Office Action Summary

10/590,472

BELLEY ET AL.

DETAILED ACTION

Doutre et al (US 5,827,982), cited in the search report, teaches a portable liquid metal filtration device as shown below in FIG. 1:

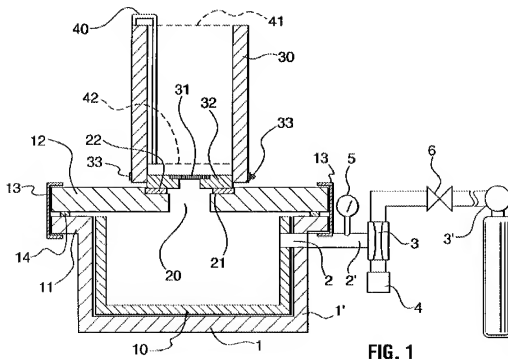
Regarding Claim 1, Doutre et al does not disclose or suggest closing the molten metal outlet shown by the area around the filter 31 with a sealable cover and then removing the sealable cover from the molten metal outlet as claimed. Regarding Claim 14, Doutre et al does not disclose or suggest a discharge trough, a vertically movable closure unit or a means for raising and lowering the closure unit as claimed.

Mochizuki et al (US 4,817,918) teaches an apparatus for filtering scraps of light metal as shown in Fig. 1:

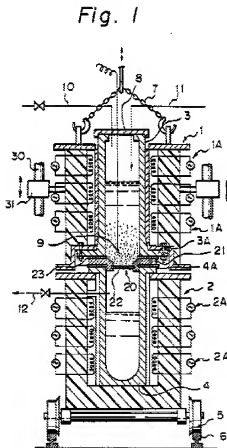
Upon achieving the required filtering temperature, the interior of the upper crucible 3 is pressurized (column 5, line 65-67), or the crucible 4 is depressurized (column 6, line 1).

Regarding Claim 1, Mochizuki et al does not disclose or suggest closing the molten metal outlet shown by the area around the filter 20 with a sealable cover and then removing the sealable cover from the molten metal outlet as claimed. Regarding Claim 14, Mochizuki et al does not disclose or suggest a discharge trough, a vertically movable closure unit or a means for raising and lowering the closure unit as claimed.

Fig. 1

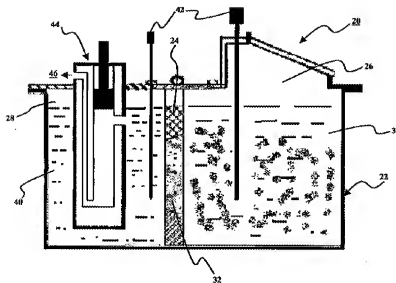
WO '748 teaches a closable outlet at 44, which is an extractor that uses a piston (page 6 lines 24-27). Regarding Claim 1, WO '748 does not disclose a filter mounted substantially horizontally, applying a vacuum, withdrawing a stream of air through a fan or air venture and releasing the vacuum as claimed. Regarding Claim 14, WO '748 does not disclose a filter mounted substantially horizontally, an exit well beneath the filter, a trough, an air conduit and valve as claimed.
